Access Compliance Report

Public Rights-of-Way

Intersection ID: 53351	Main Street: MARVIN_RD	Cross Street: SAPPHIRE_HILL_LN	Location: SE
ADA ID: F0A7E5527F88	Ramp Type: BlendTrans2	Initial Pass/Fail: Fail	Overall Compliance: No
		Severity Score: 25

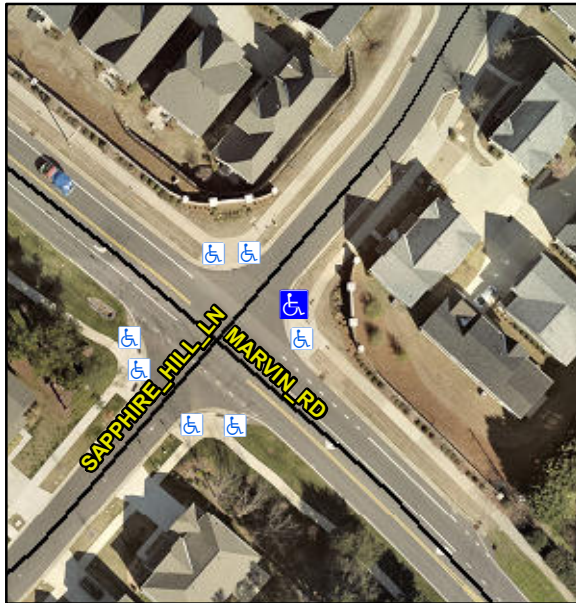
Not Found, R304.5.3

Compliance	Description	Data	Compliance	Description	Data
N/A	Ramp Length (in)	170.0	Yes	BlendTrans Slope (%)	4.8
Yes	Ramp Width (in)	54.0	No	BlendTrans XSlope (%)	15.0
N/A	Flare Type LT	N/A	N/A	Flare Type RT	N/A
N/A	Flare Slope LT (%)	N/A	N/A	Flare Slope RT (%)	N/A
N/A	Flare Traversable LT?	N/A	N/A	Flare Traversable RT?	N/A
N/A	Landing Length (in)	N/A	N/A	DWS Provided?	N/A
N/A	Landing Width (in)	N/A	N/A	DWS Contrast?	N/A
N/A	Landing Slope (%)	N/A	N/A	DWS Length (in)	N/A
N/A	Landing X Slope (%)	N/A	N/A	DWS Full Width?	N/A
N/A	Landing Curb? (Y/N)	N/A	N/A	DWS Offset (in)	N/A
N/A	Shared Landing?	N/A			
N/A	Gutter Ponding?	N/A	N/A	Gutter Slope (%)	N/A
N/A	Gutter Lip Ht (in)	N/A	N/A	Gutter X Slope (%)	N/A
N/A	Painted X Walk1?	No	N/A	Painted X Walk2?	N/A
	X Walk 1 Direction	To NW		X Walk 2 Direction	N/A
	X Walk 1 Width (in)	N/A		X Walk 2 Width (in)	N/A
	X Walk 1 Slope (%)	0.4		X Walk 2 Slope (%)	N/A
	X Walk 1 X Slope (%)	8.8		X Walk 2 X Slope (%)	N/A

N/A	Ramp inside XWalk1?	N/A	N/A	Ramp inside XWalk2?	N/A
	Road Slope (%)	8.8		Clear Space?	N/A
	Road X Slope (%)	0.4	N/A	Clear Space to XWalk (in)	N/A
N/A	Any Obstructions?	N/A	N/A	Storm Grate/Utility Hazard?	N/A
	Obstruction Type			Storm Grate/Utility Type	
		N/A			N/A
			Yes	Surface Condition? (G/P)	Good
			No	Curb Slope (%)	7.0

Remove & Replace Curb Ramp With Two New Directional Ramps or Equivalent.
